From: Nate Novak [Nate Novak@jjr-us.com]
Sent: Friday, September 28, 2007 5:02 PM
To: Murphy, Brad; Cooper, Jonathan D - WHS
Cc: denny.meikleham@lodgeworks.com; White, William F (22246); nlb@alexandercompany.com; ajw@alexandercompany.com; tcm@alexandercompany.com; Don Marvin; jeff.krehbiel@krehbielarchitecture.com
Subject: Hyatt site plans for Plan Commission

Attached please find 2 options for the Hyatt Place drop-off we plan to talk through at Monday's Plan Commission meeting

Sidewalk Shift

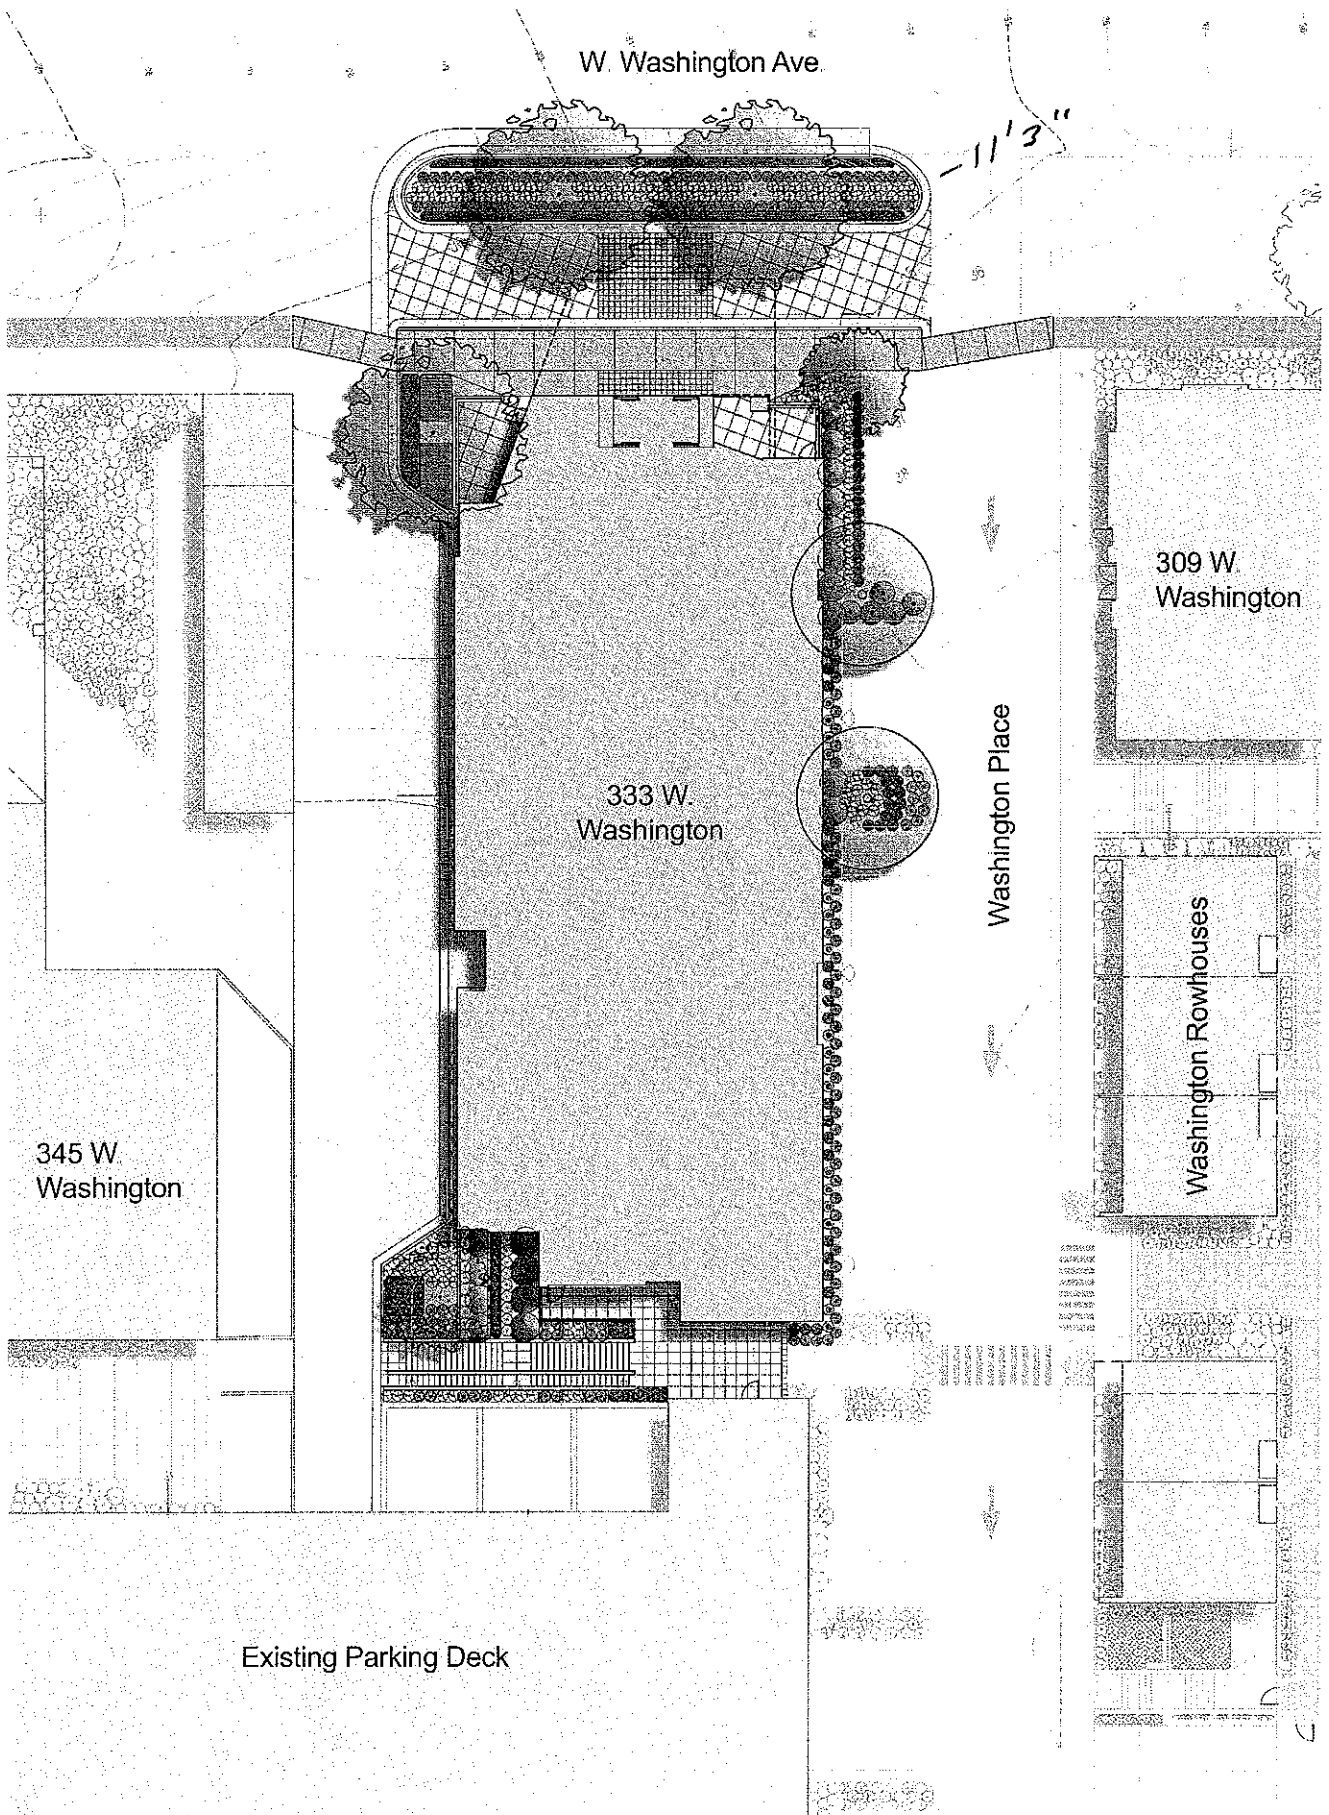
In this option you can clearly see the team has tried to maintain as much green space in the terrace as possible. It was recommended to the team to try and maintain ~ 12'-0" of terrace. To do this, we have modified the building entrance by pulling the vestibule and building façade back into the building ~3'-10". To maintain the dimensions listed above in addition to the 12' terrace, the sidewalk shifts its alignment south into the site (though still in the right of way). The terrace actually measures slightly less than 12' at 11'-3" which is a compromise from the suggested 12'. Our compromise is the result of the following building analysis

The hotel needs to maintain square foot areas on floors 2-11 to efficiently layout rooms and hotel services. The room layout starts to drive the building structural column locations based on the SF efficiency. The previous vestibule protruded beyond the first row of structural columns under the porte cochere. To accommodate this new design, the team pulled the vestibule back to be flush with this row of columns. The 9" dimension needed to accommodate the 12' terrace means modifying the column locations which then compromises the efficiency of the room and services layout. A revised column location would result in fewer rooms per floor which would drive the hotel to potentially add a floor to make up the density needed to be economically feasible. Hence the compromise in the terrace
